ADDITIONS & ALTERATIONS TO:
OLD GREENWICH SCHOOL
285 Sound Beach Avenue
Old Greenwich, CT 06870
STATE PROJECT # 057-0115 EA/RR/CV

PROJECT MANUAL
BIDDING AND CONTRACT REQUIREMENTS
INVITATION TO BID #03
May 15, 2025

ADDITION & ALTERATIONS TO: OLD GREENWICH SCHOOL
FOR THE TOWN OF GREENWICH
STAE PROJECT NO. 057-0115 EA/RR/CV
MAY 15, 2025

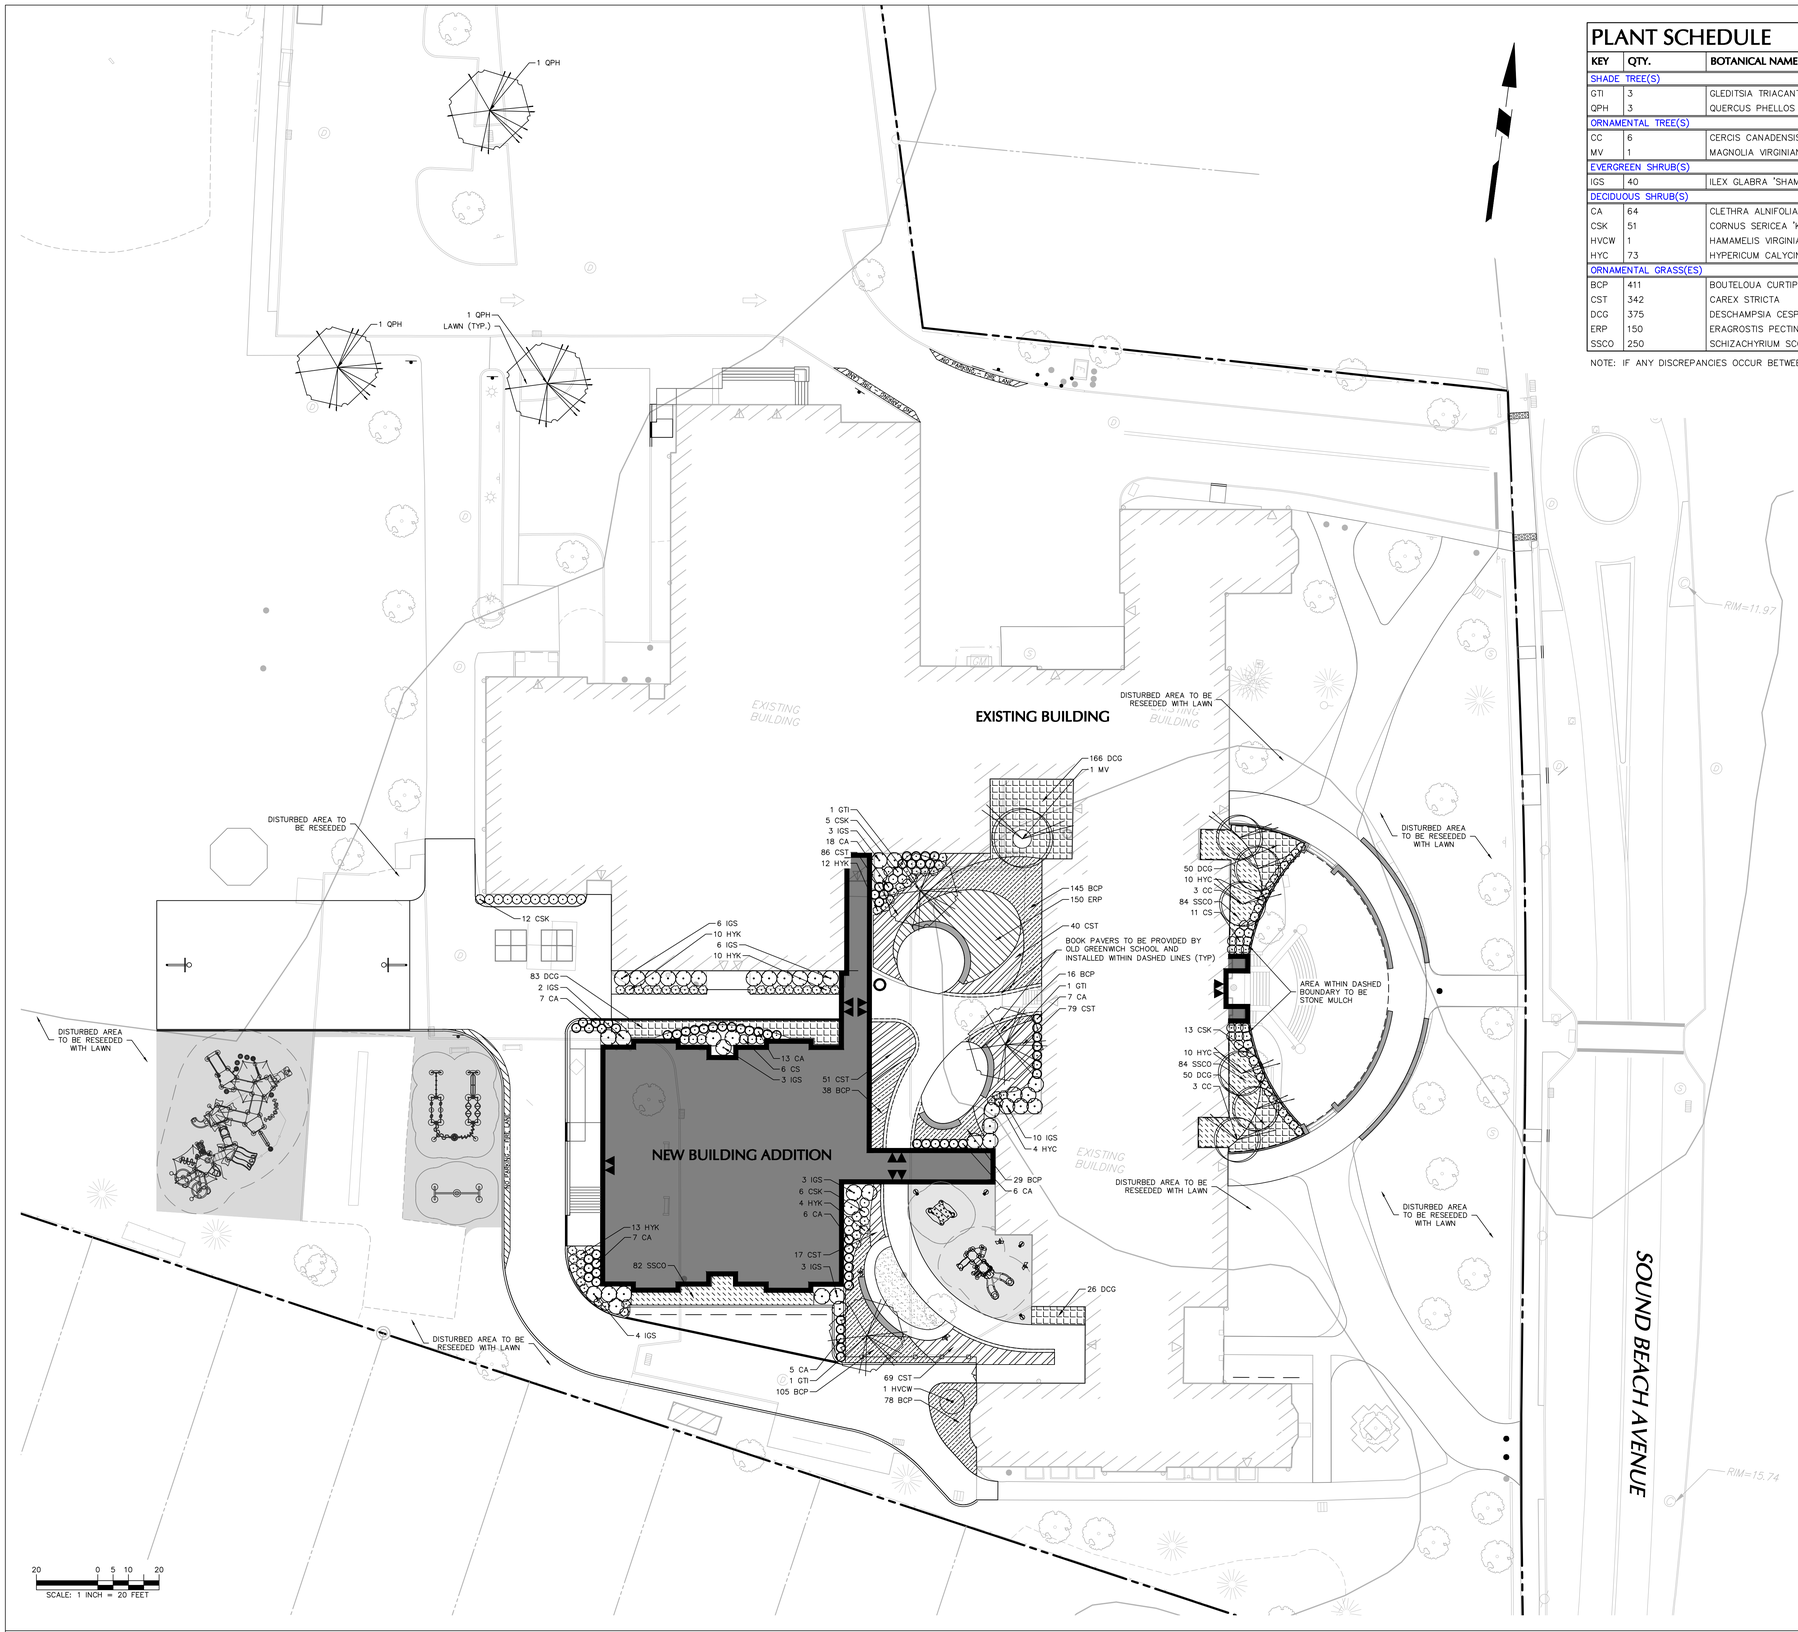
- **RFI #8** **Question:** Please confirm the stone mulch is within the CSK trees. The south planting bed lists the Red Twig Dogwoods as CSK, however, north list tress as CS. Please advise
    Response: Stone mulch is proposed within the planting areas adjacent to the main entry to the school. Similar to bark mulch, stone mulch should be place over trees, shrubs and ground plantings. 11 CS noted north of the main entry should be 11 CSK. Refer to revised Drawing LP101 in Bulletin #2.

- **RFI #9** **Question:** LP101 - HYK is shown on the planting plan, however, there is no HYK. Was this meant to be HYC?
    Response: HYK is meant to be HYC. Refer to revised Drawing LP101 in Bulletin #2. Quantities within plant schedule are accurate; 73 HYC plants proposed.

Date: 11/22/2024
Scale: As indicated
Drawn By: JM
Project Number: 22-382
Drawing Number: A111

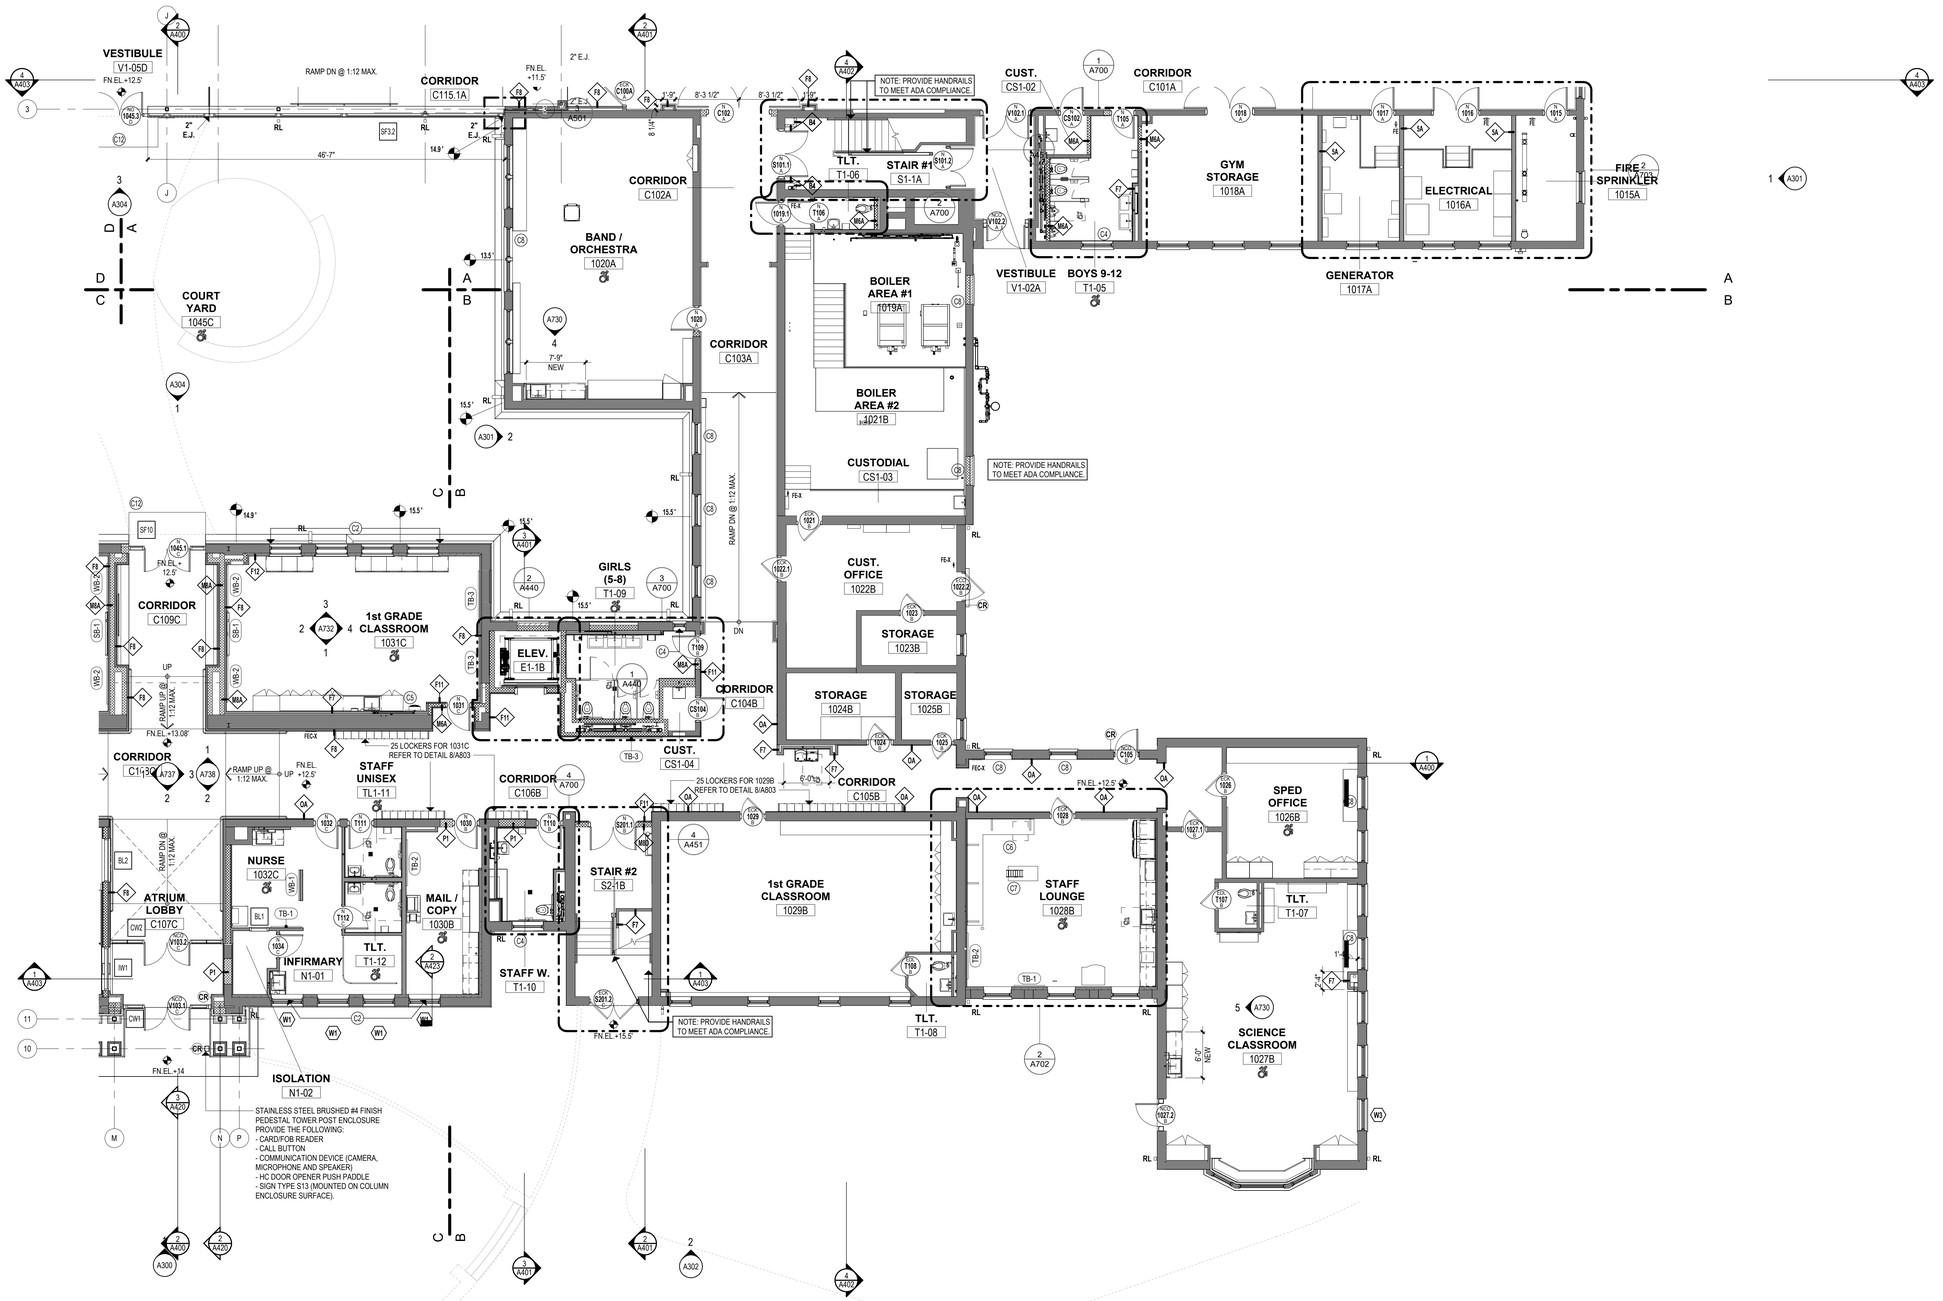
c) **BID PACKAGE 1.4.1 – MASONRY**
- **RFI #02: Question:** Wheel Chair Lift - Drawings A111 and A143 please identify wall types for GWB and CMU. Is wall capped?
  Response: CMU Wall Type M6A and GWB Wall Type 3A. Refer to detail 11/A803 for clarification - 1½" thick wood cap with 1/2 reveal at knee wall. Wood Cap to be sanded smooth and stained.
- **RFI #03: Question:** Is demolition required for new post in Server Room 1008A for steel post? CMU patch work?
  Response: Refer to architectural sheet A011 for demolition notes. The structural post HSS 4x4x5/16 is to be anchored to the existing tunnel foundation wall. Sawcut and patch the existing CMU as required to center the new steel post to the tunnel foundation wall.

Response: BL2 is hollow metal borrowed Lites. Refer to Bulletin #3 for revised Drawing A600.
     - **RFI #97** **Question:** Drawing A111 Corridor C115.1A – just south of door ECK C100A A, two new 2" E.J. are called for.

a. Is the assumed floor EJC existing to remain? Or replaced?
       b. Drawing A251 does not call for a ceiling E.J. please confirm this is not required.

- **RFI #98** **Question:** Drawing A111 Corridor C100 – the existing expansion joint looks exposed at Door opening N 1005 A. No E.J. are called for. Please confirm the floor, walls and ceiling/soffit are ALL existing to remain.

Response: a. EJ to be new, refer to Section 079500.
       b. EJ is required between gyp soffit & ACT; similar to the EJ indicated in Detail 12/A260 and/or specified in Section 079500."

Drawing Number: A112

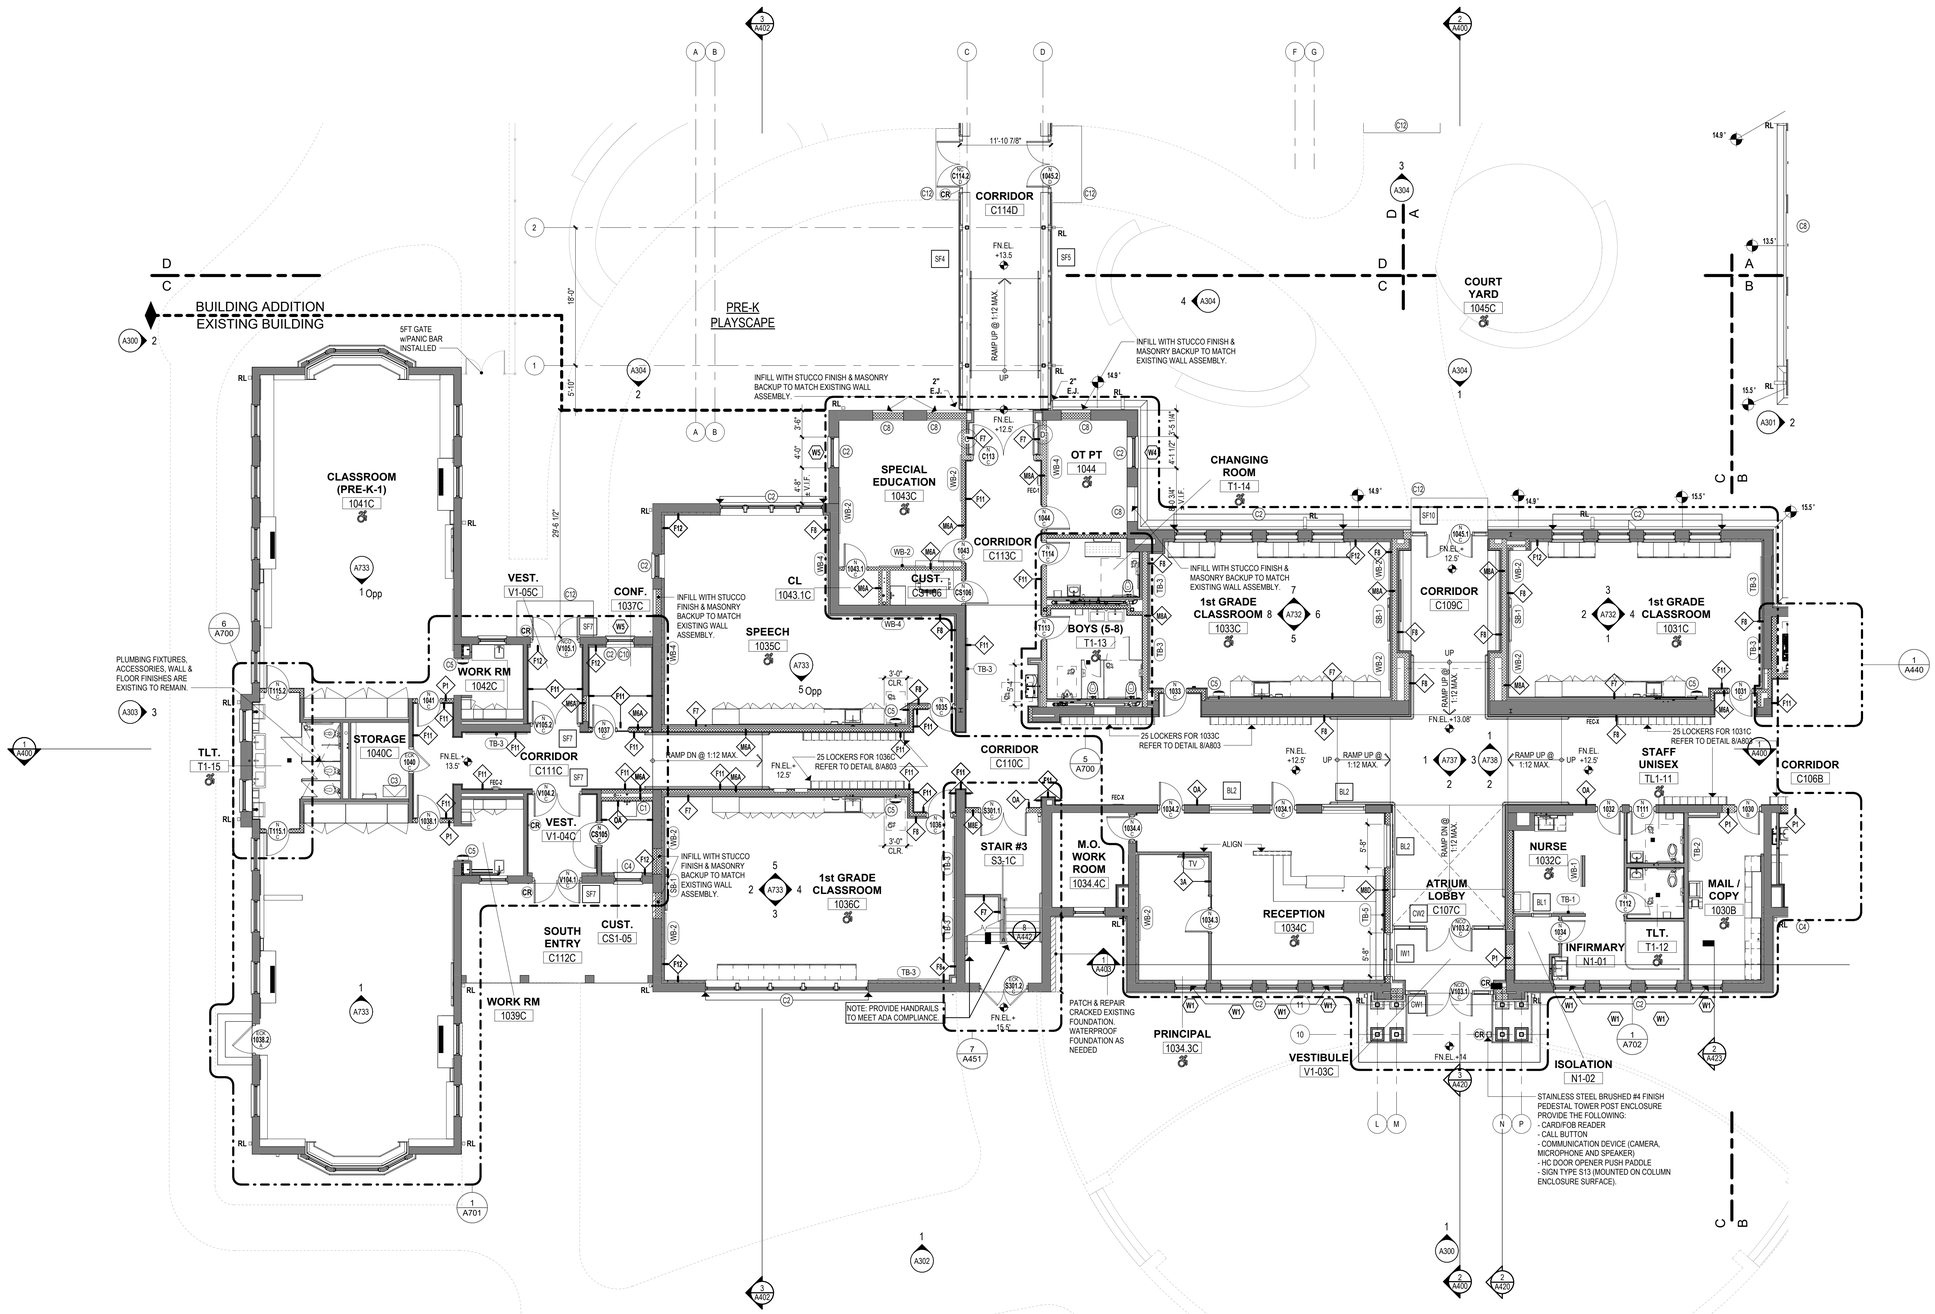
- **RFI #91** **Question:** Drawing A112 – Please clarify which Bid Package is responsible for these keynotes:
  a. Keynote C1 (By BP 1.9.1?)
  b. Keynote C4 (by BP 1.8.1?)
  c. Keynote C9 (By Food Service?)
  d. Keynote C11 (By BP 1.6.1?)
  Response: a. Keynote C1 - 4'x8' 20 ga stainless steel panel behind mop sink to be furnished and installed by BP 1.10.1
  b. Keynote C4 - Privacy film in all bathrooms with exterior windows to be furnished and installed by BP 1.8.1
  c. Keynote C9 - the stainless steel wrap in the Kitchen is to be furnished and installed by BP #1.9.1
  d. Keynote C11 - Salvage Existing trim at Area Wardrobe removal and reinstall - Salvage by BP #1.2.1 - Demolition & Haz. Abatement - Reinstallation by BP # 1.6.2 - Architectural Woodwork

Response: Material is to be plywood per Section 061600.
     - **RFI #116** **Question:** The new floor access door in Room 1028B (drawing A112) is a different size and location as the existing one (drawing A012). Please confirm that BP 1.9.1 is ONLY providing the floor door, and preparing the (assumed) new floor opening involving demo, steel and concrete is by other bid packages.
